# Additional Information

**From:** [Montgomery, Kelley A](#)  
**To:** [Goetze, Phillip, EMNRD](#); [Murphy, Kathleen A, EMNRD](#)  
**Cc:** [Lamkin, Baylen, EMNRD](#); [Maxian, Amanda M](#); [Rose-Coss, Dylan H, EMNRD](#)  
**Subject:** [EXT] RE: Hobbs Guzzler SWD No. 1 Application - Revised AOR Submittal  
**Date:** Tuesday, April 20, 2021 4:54:00 PM  
**Attachments:** [image001.png](#)  
[Hobbs SWD 1 AOR 4-20-21.pdf](#)  
[Hobbs Guzzler AOR Map 4-20-21.pdf](#)

RE: Hobbs Guzzler SWD No. 1; 30-025-43702; Appl. no. pMAM1903249035; application to plugback and dispose in San Andres Fm

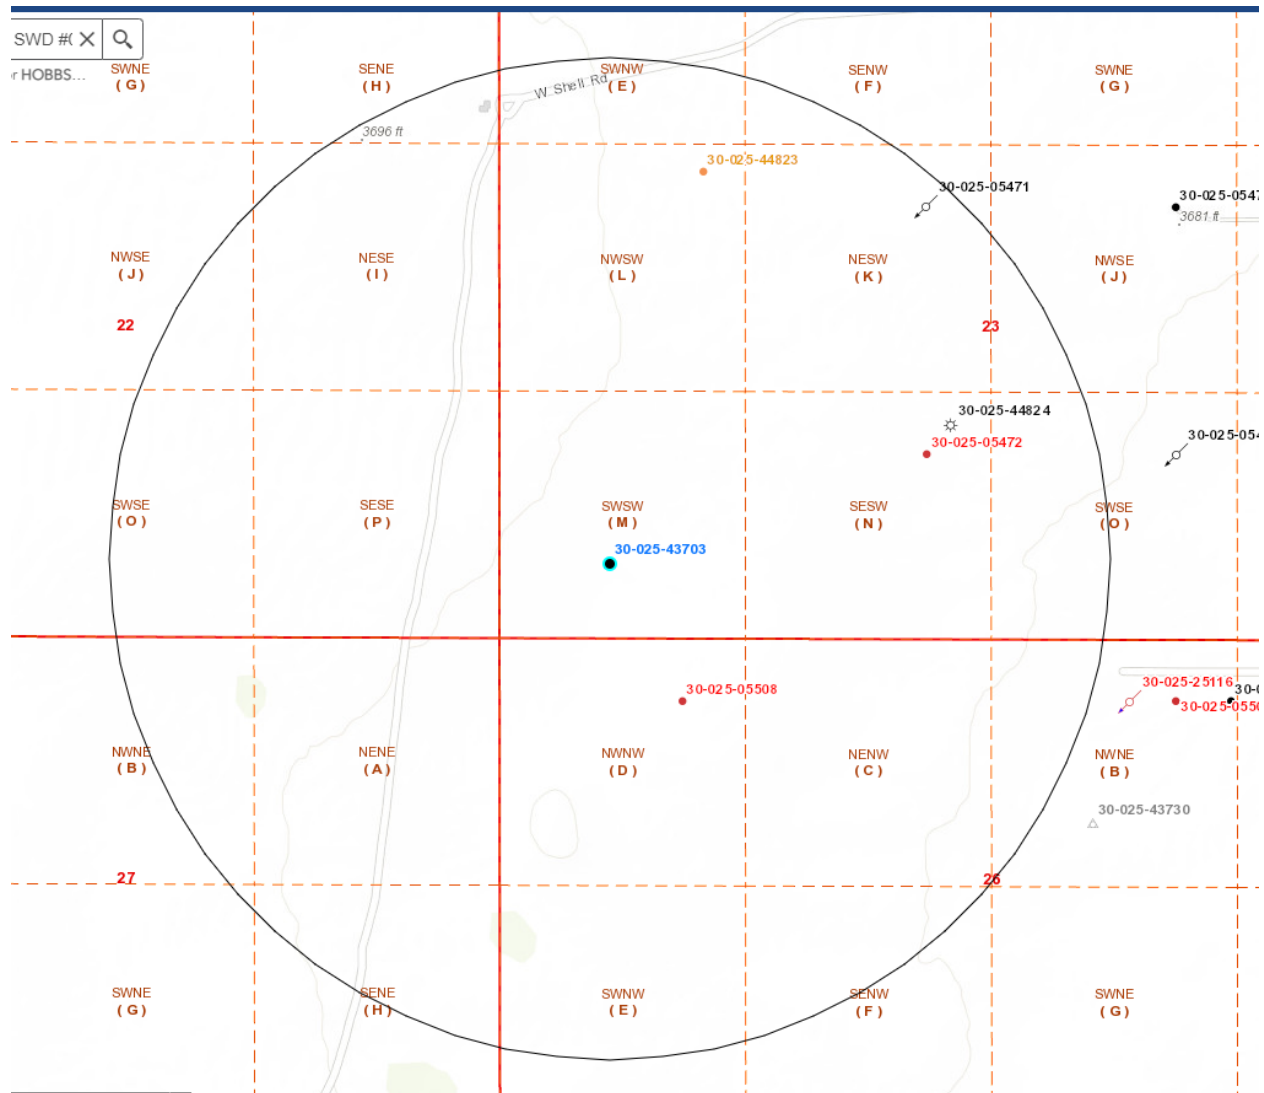
I believe the plug depth, formation and measured depth matched with the numbers 1-7 are reversed.

Also, the perf interval is 4790 to 5898, but the intermediate casing was set at 5020 so the perfs would not go thru 2 casing strings I believe. Did the perf depths change with the setting of the intermediate casing to 5020? Or am I reading this incorrectly.

Additionally, Oxy needs to address the conflict in the application for the proposed lower limit of the injection interval. The re-completion well diagram shows seven plugs with the shallowest being 5898 feet deep, also the depth of the deepest perforation. It references the plug location as isolation for the Glorieta Formation. Yet, the mud log provided in the Division well record has a formation top for the Glorieta as 5486 feet (TVD). If the lower limit of the San Andres is 5486 feet, then the order can only be issued for the San Andres interval with a total depth 5486 feet and not the application's proposed depth of 5900 feet. This would also require a modification of the well design to include a CIBP with cement cap that is no

deeper than 100 feet from 5486 feet (or less than or equal to 5586 feet).

The plug numbers did get reversed between the diagram and the table, but depths are accurate. The perf interval is planned to be 4790-5898' which is above and below the 9 5/8" casing shoe set at 5020'.

Attached is the diagram showing proposed configuration. The plug numbers were reversed but depths are from 10603' to 5898' to isolate zones from Woodford up to Glorieta.
